**DRAINAGE LETTER TO AMEND;  
MASTER DEVELOPMENT DRAINAGE PLAN  
UPDATE FOR WOODMEN HEIGHTS AND FINAL  
DRAINAGE REPORT FOR FOREST MEADOWS  
FILING NO. 1 AND NO. 4**

**(ALLEY VACATION)**

**November 2008**

Project #08-001

**FOREST MEADOWS - AREA 2**  
**DRAINAGE MAP**

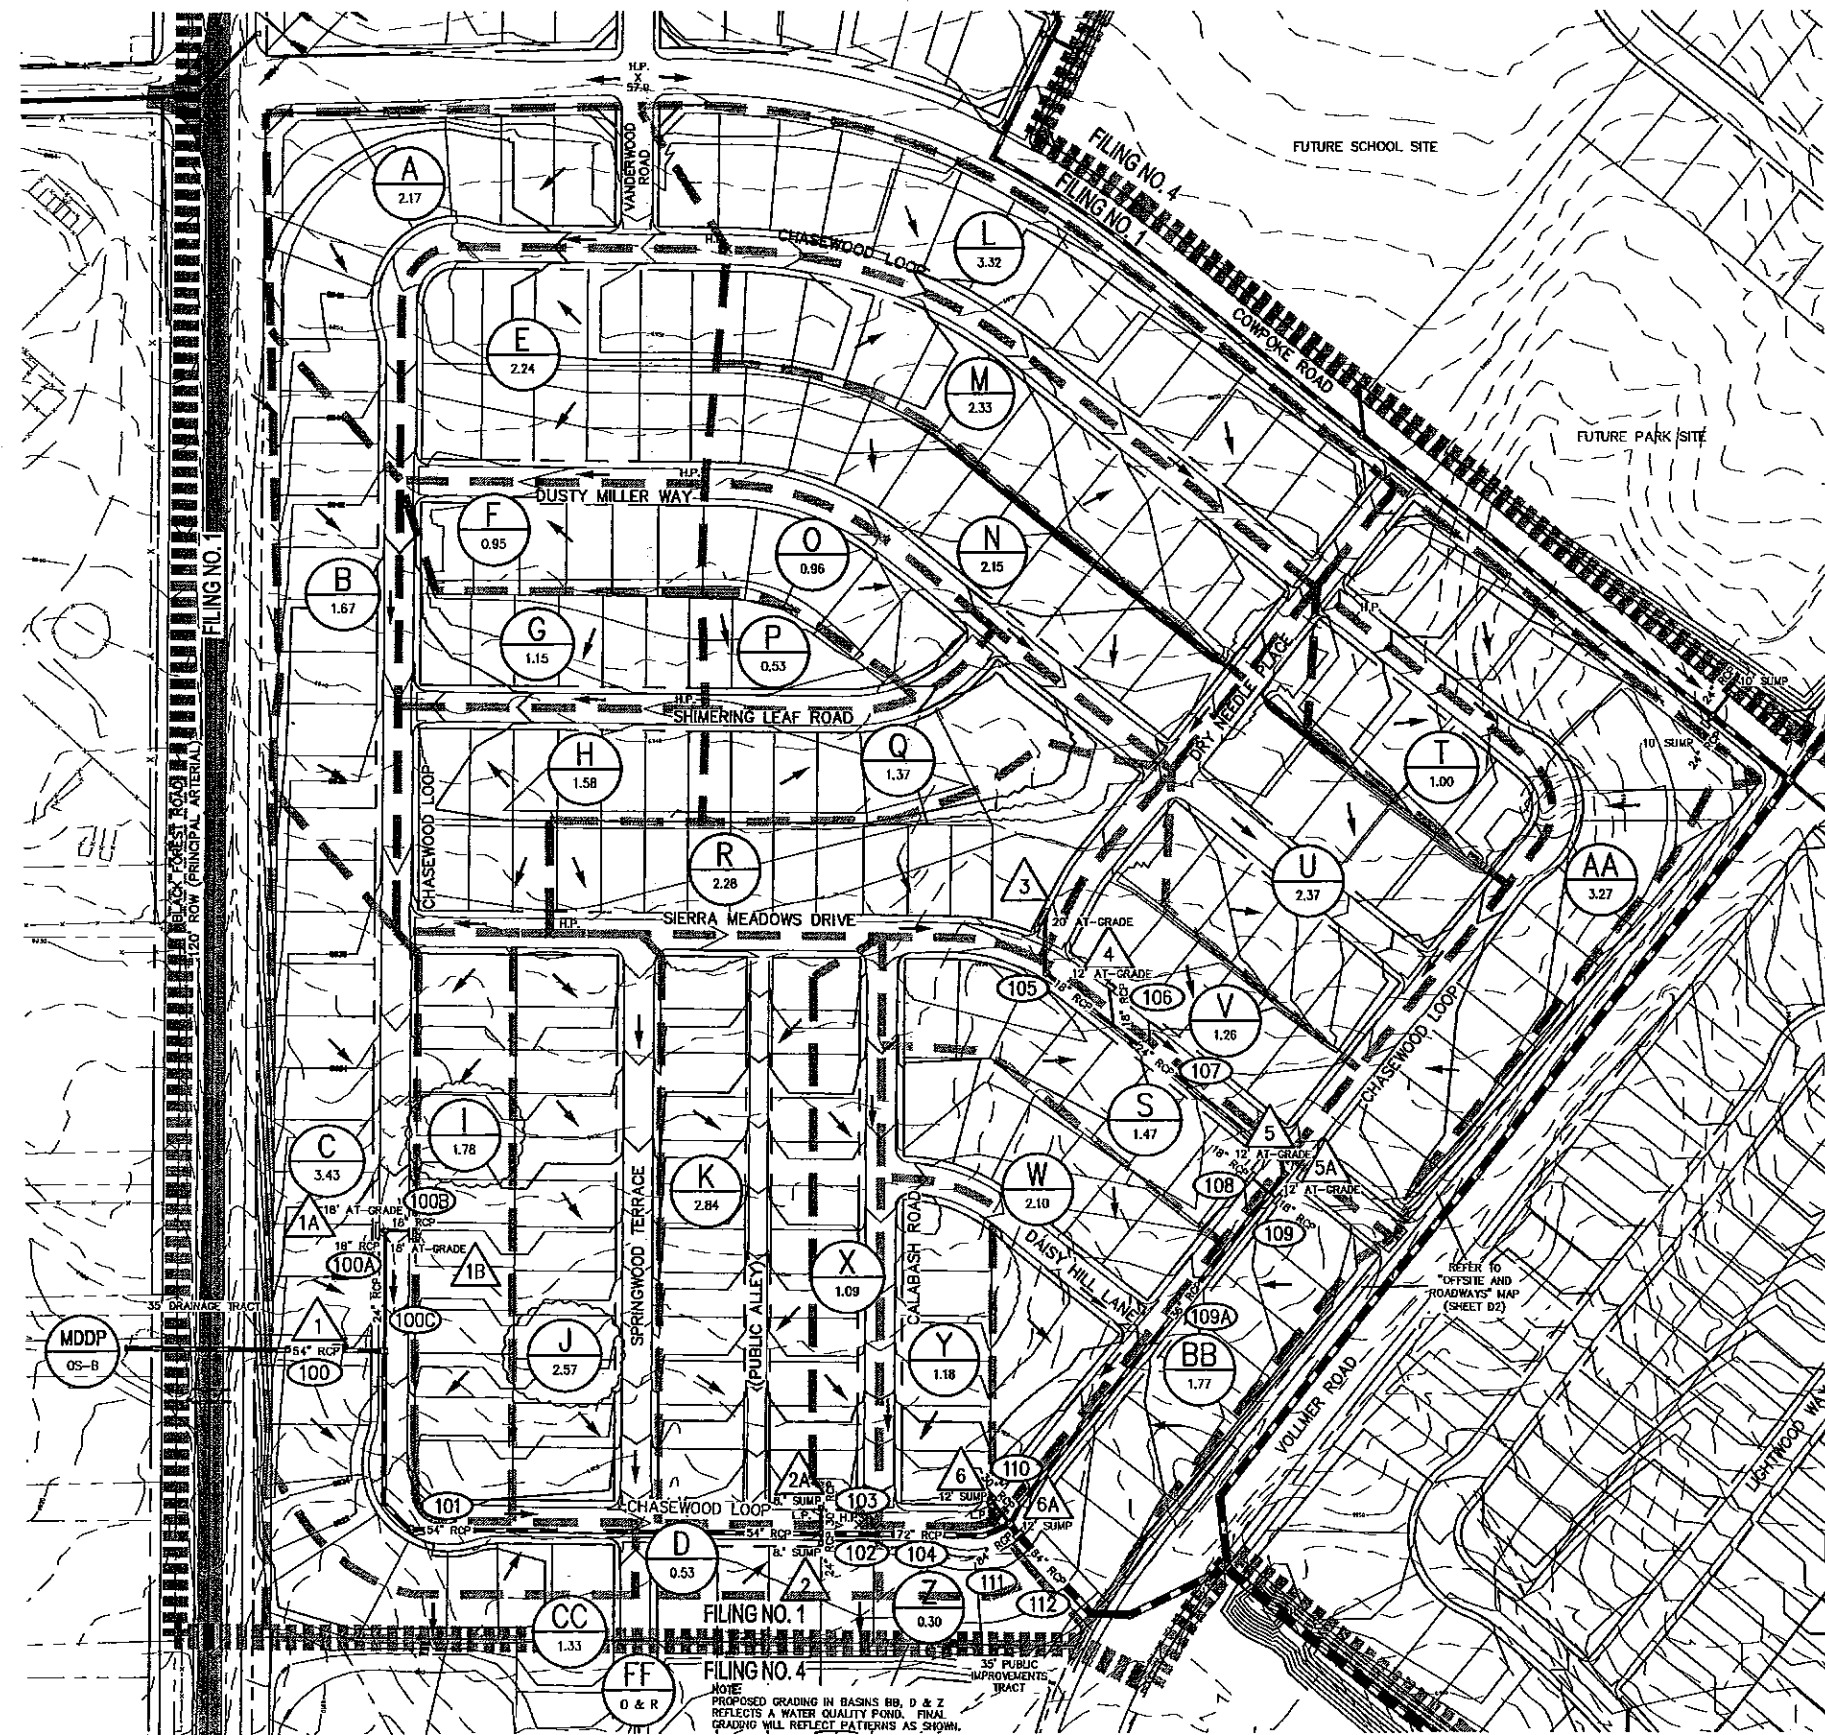
AMENDED NOVEMBER - 2008 TO VACATE ALLEYS IN BLOCKS 14, 21, 22 SEE DP AMENDMENT CPC PUD 05-040-A2MN08
